Open Water Peer Review Panel Monitoring Plan Recommendations for AGDC's Alaska LNG Proposed Construction Project in Prudhoe Bay, Alaska

The Open Water Peer Review Panel discussed and reviewed the marine mammal monitoring and mitigation plan (4MP) for the Alaska Gasline Development Group's Alaska LNG (AK LNG) Construction Project in Prudhoe Bay, Alaska. Panel members answered the questions below set forth by the National Marine Fisheries Service's (NMFS) Office of Protected Resources (OPR) and provide the following recommendations. Answers to, and recommendations based on, the specific questions were developed using the general monitoring requirements outlined in the Marine Mammal Protection Act (MMPA) implementing regulations and further guidance provided by OPR, which were included in the Instruction document and have been copied into this document below the questions.

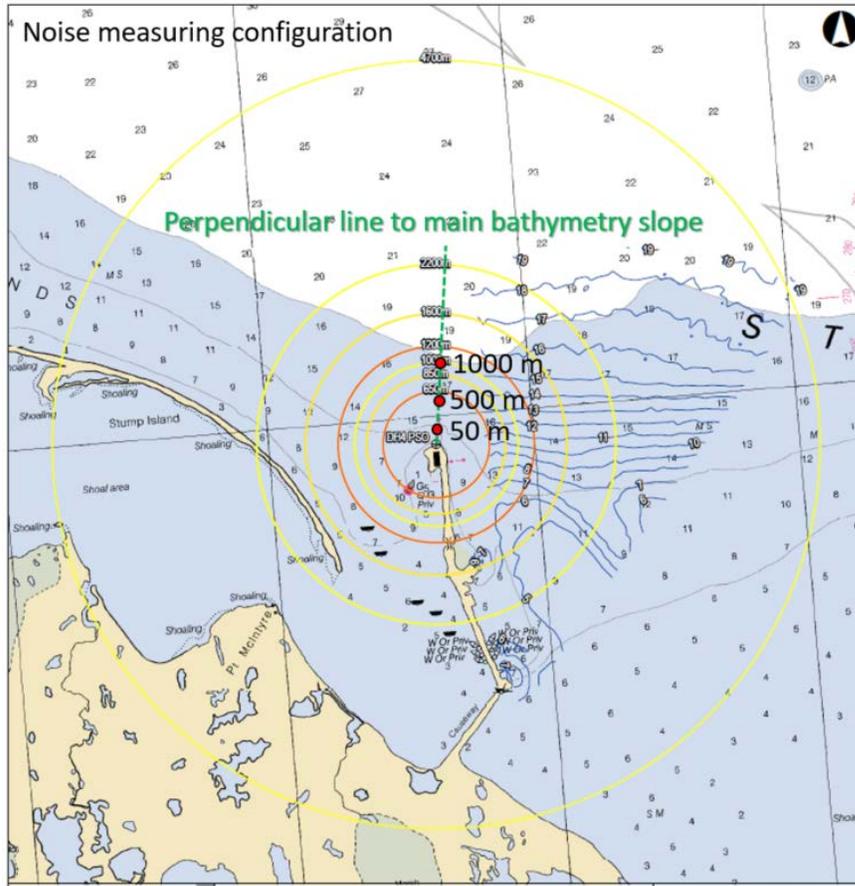
- 1) Sound source verification: At the start of pile installation for each type of pile type, dimension, or installation method, the three units (or more for improved accuracy) should be deployed in a line perpendicular to shore from the pile driver location at different distances. The simplest approach would be to follow a near, medium, and far approach with equidistances between moorings. For example, one unit in the near field at 10 to 50 meters from the pile, a second unit at a farther distance, such as 500 meters from the pile, and a third buoy at 1000 meters (Fig. 1). However, a possible better alignment of the placement of the moorings would be following a logarithmic approach, where distance between moorings represent values which are in an equal ratio, for example 10, 100, 1000 m from the pile driver, as the results will likely provide a better fitting for an exponential regression curve to calculate propagation loss. Distances should be discussed with the manufacturer of the PAM system to make sure the dynamic range and system gain is appropriate for this task (i.e., they might want a lower gain for the closer buoys, and higher gain for the farther units). This configuration should be maintained for at least

60 minutes of noise producing activity, to allow calculating median values from a representative time series. For example, after 1 hour of pile driving, the buoy at 50 and 500 m (or 10 and 100 m for the logarithmic approach) can be moved from its location to another farther away, closer to the edge of the Level B harassment zone, to start the monitoring configuration.

Figure 2. Example of monitoring configuration for real-time PAM. Three moorings (red dots) placed at equidistant intervals from each other with their respective detection ranges of 860 m (blue areas) corresponding to their distance to the edge of the 4,700 m monitoring zone.

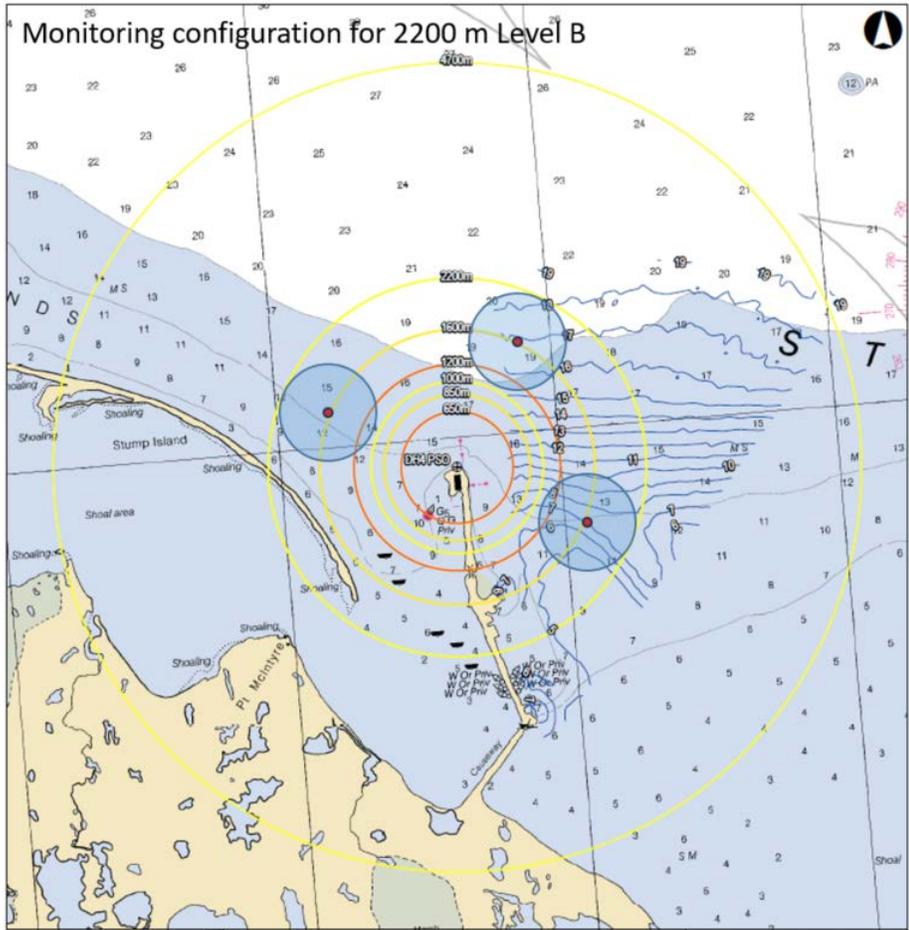
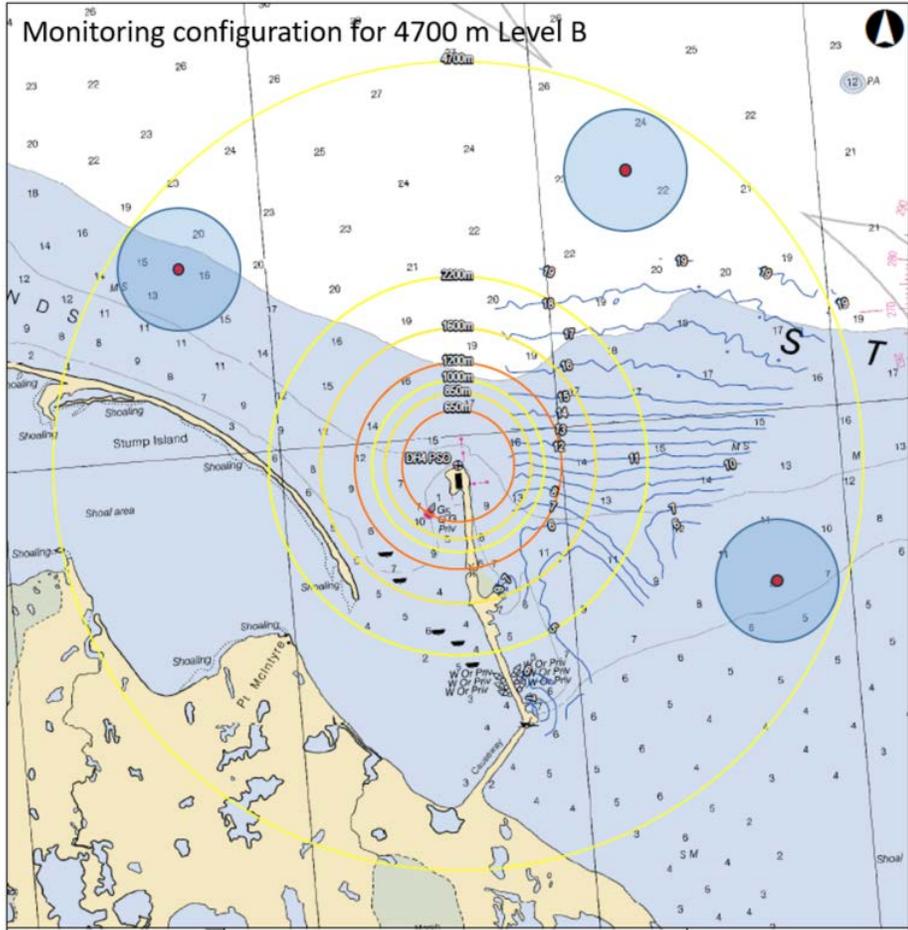
- 2) Detection of marine mammals in the far field: Figures 2-3 present monitoring configuration designed to maximize detection of marine mammals entering the Level B harassment zone, in those portions of the zone too far for observers to see. Ideally, the three (or preferably six) buoys should be placed at equidistant intervals from each other to maximize and homogeneously distributed coverage, and all at the same distance to the edge of the Level B harassment zone. In order to assume that each acoustic detection is a take, the acoustic detection range from the target marine mammal species should be considered (see Table 1), and that range should be used to place the buoy inside the Level

B harassment zone at that specific distance from the edge of the Level B harassment zone. For example, if the detection range for beluga whale vocalizations is estimated to be 860 m, all buoys should be placed 860 m from the offshore border of the Level B harassment zone. To determine buoy placement in a scenario such as this, where multiple species with different source levels may be present, the panel recommends using the detection range associated with the most likely species. In this case, small pinnipeds (e.g., spotted and ringed seals) are by far the most likely marine mammals to be present in the operation area.

The buoy configuration should be revised for every change in monitoring zone. For example, when monitoring of the Level A harassment zone changes from 1,200 to 1,600 m, the buoys should be moved to their respective new locations to capture this increase in distances.
